**BROWNS FERRY NUCLEAR PLANT (BFN) - UNIT 2 - TECHNICAL
SPECIFICATIONS (TS) CHANGE 420 - SAFETY LIMIT MINIMUM
CRITICAL POWER RATIO (SLMCPR) - CYCLE 13 OPERATION**

Technical Specifications (TS) Change 420 Safety Limit Minimum Critical Power Ratio (SLMCPR) Unit 2 Cycle 13 Operation

Proposed Technical Specifications Changes (mark-up)

Figure 1 Reference Core Loading Pattern – Cycle 13

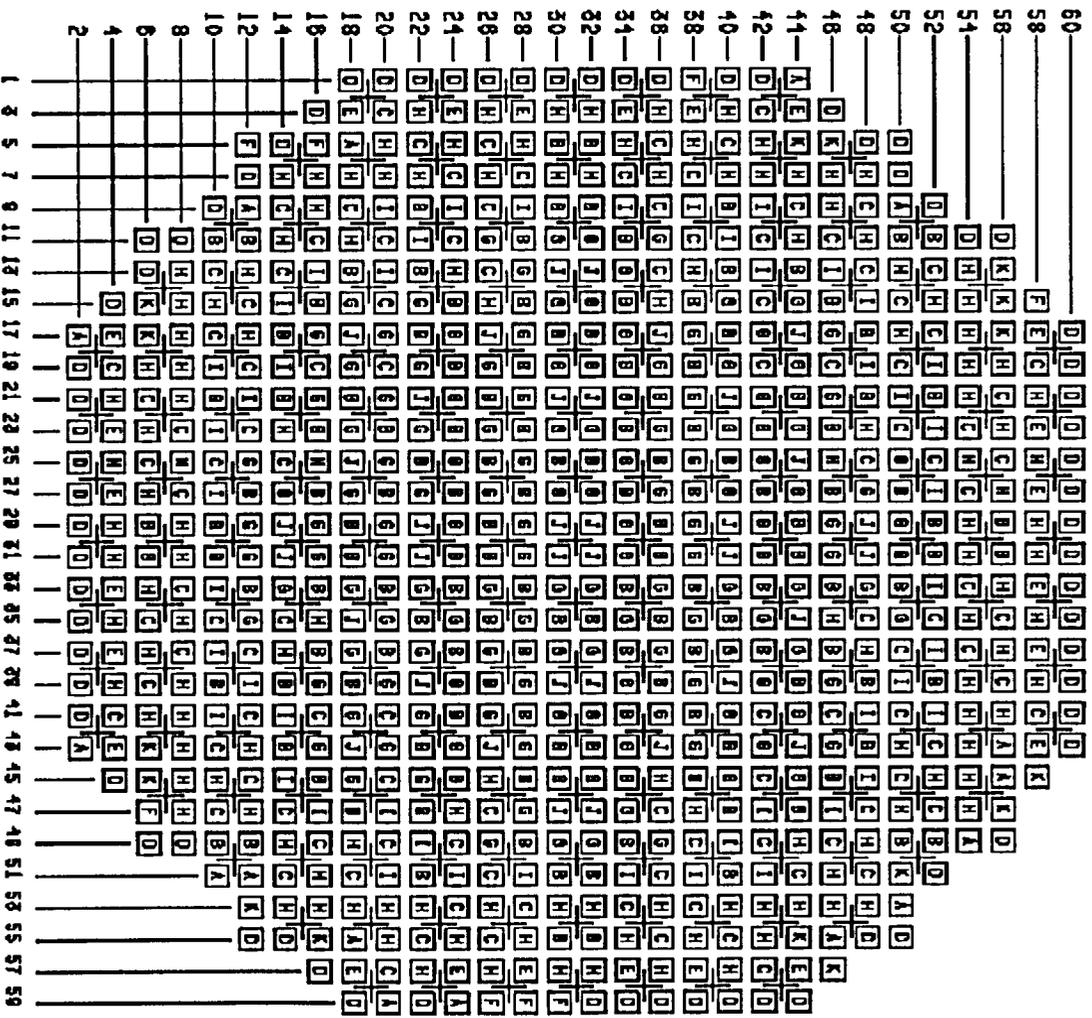
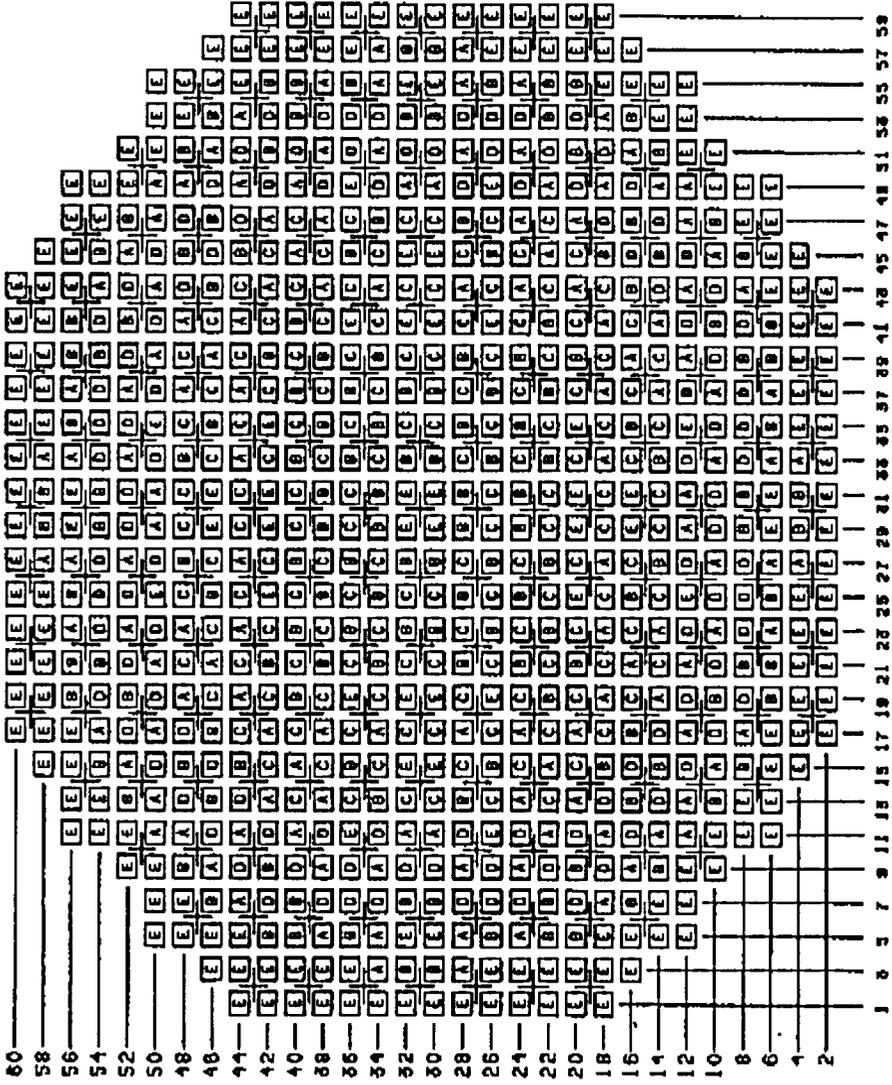
In comparing the Browns Ferry Unit 2 Cycle 13 and Cycle 12 SLMCPR values it is important to note the impact of the differences in the core and bundle designs. These differences are summarized in Table 1.

In general, the calculated safety limit is dominated by two key parameters: (1) flatness of the core bundle-by-bundle MCPR distributions and (2) flatness of the bundle pin-by-pin power/R-factor distributions. Greater flatness in either parameter yields more rods susceptible to boiling transition and thus a higher calculated SLMCPR.

The core loading information for Browns Ferry Unit 2 Cycle 13 is provided in Figure 1. For comparison the core loading information for Browns Ferry Unit 2 Cycle 12 is provided in Figure 2. The impact of the fuel loading pattern differences on the calculated SLMCPR is correlated to the values of [[]]
